Application for Variation of Conditions

Existing Planning Consent Ref: 2023/1029

Site Address: Cannon Hall Museum, Bark House Lane, Cawthorne,
Barnsley, S75 4AT

Additional roofing & drainage works to Cannon Hall.

Figure 02: Felt lined Timber gutter and UPVC pipe to be replaced in element 01.

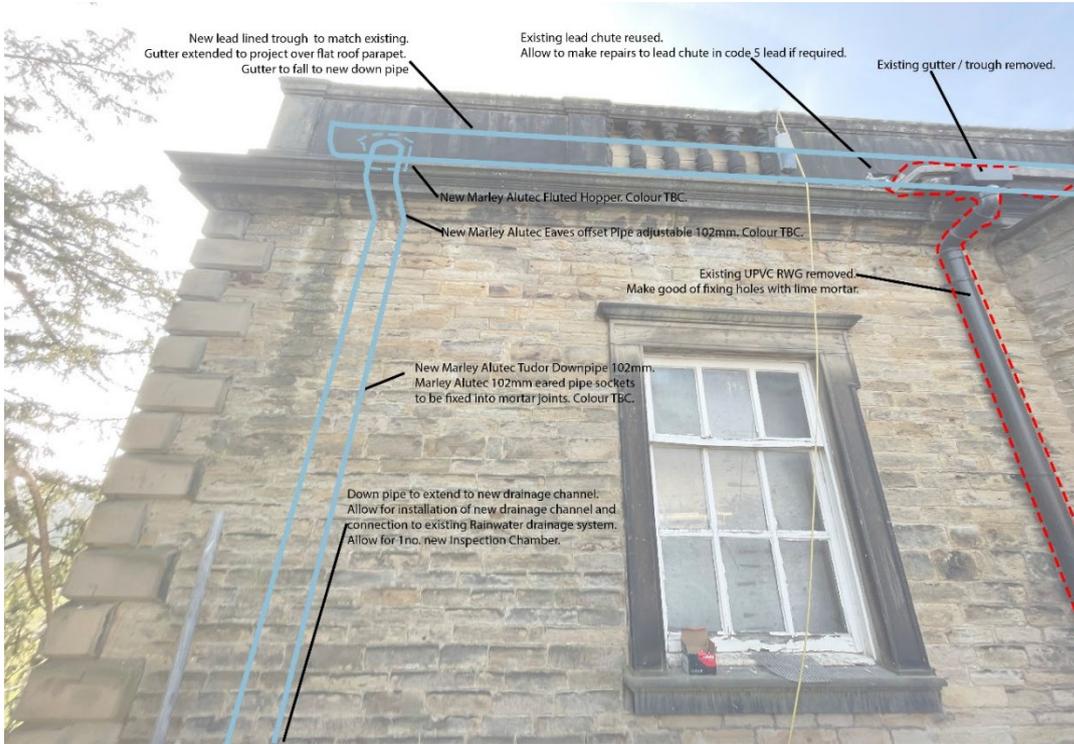
The existing black UPVC drainage pipes and felt lined timber troughs are removed. A new lead lined trough is installed, extended to the South side of the hall. A new black cast aluminium downpipe and hopper are installed and run down the side of the hall to ground level. A new drainage channel will be installed beneath the path to the south of the hall. New rainwater goods to be Marley Alutec range.

The existing rainwater goods are not of historic interest. They are likely a 20th century replacement due to their UPVC and felt lined construction. The existing rainwater drainage route runs water onto the lower section of flat roof before it is then discharged into a perimeter gutter, providing a potential source for blockage if debris built up between the newly installed lead bays.

Figure 03: Marked photograph showing element 01's proposals.

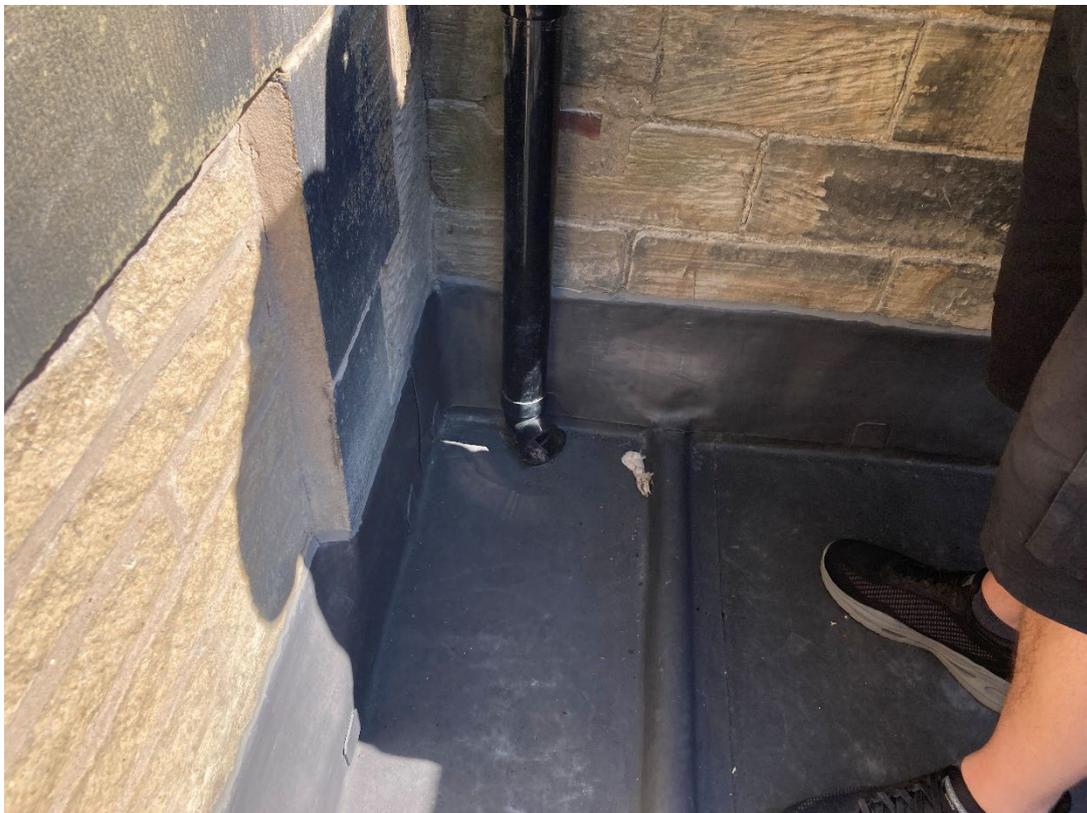
The proposed materials will be cast aluminium and finished in black, an improvement and more sensitive finish for the historic building compared to those presently installed. The extension of the timber drainage trough further along the side will have minimal impact on the building and is largely

The installation of a new drainage channel will not impact any historic or significant fabric, only affecting the modern perimeter path to the hall.
